Technical product information

Topic	Reverse camera image - Blurred
Market area	Bentley: worldwide (2WBE),Hongkong-Macau (5HK)
Brand	Bentley
Transaction No.	2054229/4
Level	EH
Status	Released for publishing
Release date	22-Oct-2020

New Continental GT and New Continental GTC

Figure 1

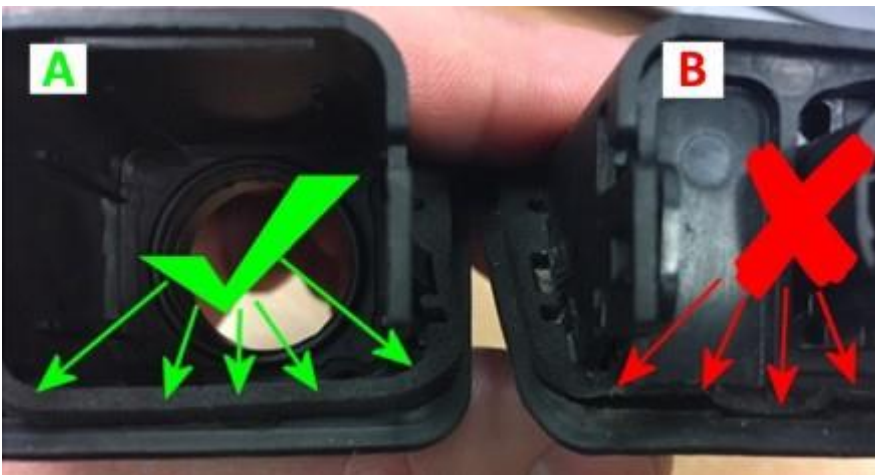
3) Referring to Figure 1 - Carry out an inspection of the reverse camera holder foam seal

- Should the seal be as shown (Point A) this is to correct specification, should the seal be at the correct specification and the reverse camera has evidence of moisture on OR within the lens - Allow the camera to fully dry out ensuring that no moisture is evident then carry out the modification instructions as detailed in step 5 - Reverse camera holder modification instructions
- Once the modification has been completed - Refit the reverse camera holder/reverse camera ensuring the seal is fitted/located correctly - Refer to Repair manual Rep.Gr94 IMPORTANT: Ensure the instructions within the Repair manual are strictly adhered to including all camera calibration instructions

4) Should the seal be as shown in Figure 1 (Point B) this is not to correct specification, a new replacement holder should be sourced/ordered

An improved reverse camera holder is under development which will include a drain hole, until this part is available the modification detailed in step 5 must be followed on all replacement holders in which the drain hole is not evident

Figure 2

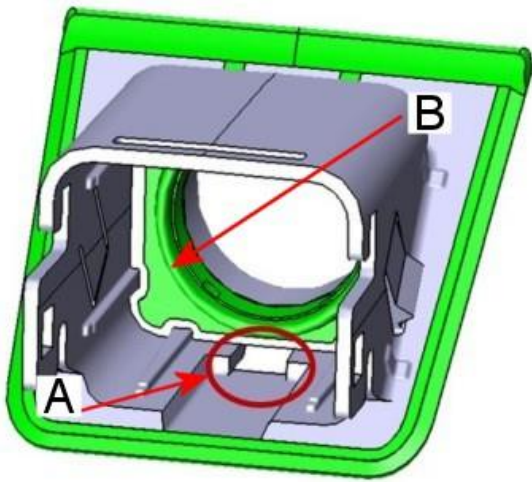
IMPORTANT: REFERRING TO FIGURE 2 - PRIOR TO ADDING THE HOLE (Point A) THE OPERATIVE SHOULD FAMILIARIZE THEMSELVES WITH THE LOCATION OF THE SEAL (Point B)

The seal should remain intact to ensure the seal does not split or dislodge away from the housing as the fitting position of the camera may be compromised should the seal be damaged

Figure 3

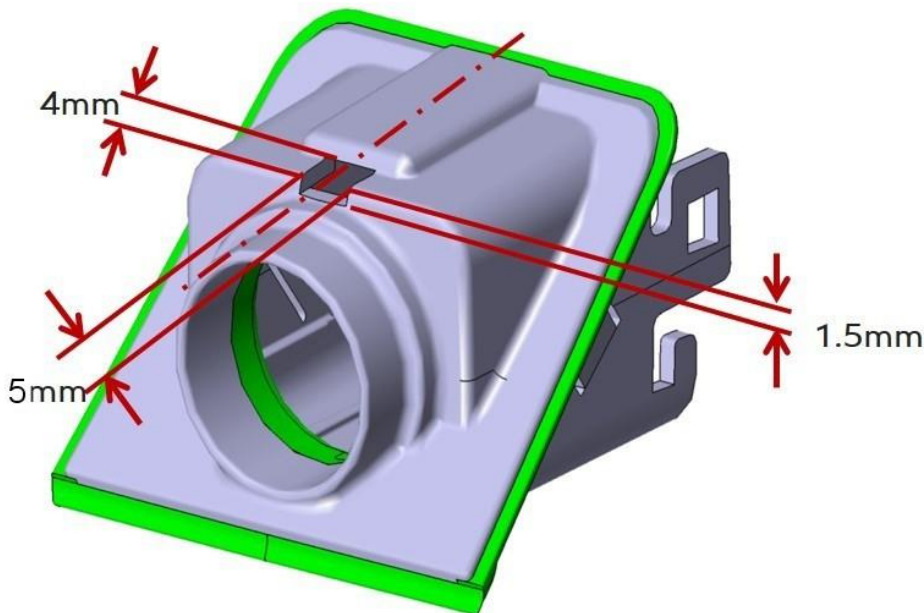
- Referring to Figure 3 - Use a 2.5mm drill bit to make an initial pilot hole
- Once the pilot hole has been made use a suitable file to square the hole to the dimensions shown in Figure 3 IMPORTANT: Do not exceed the given measurements
- Ensure all debris/rough edges are removed from the hole
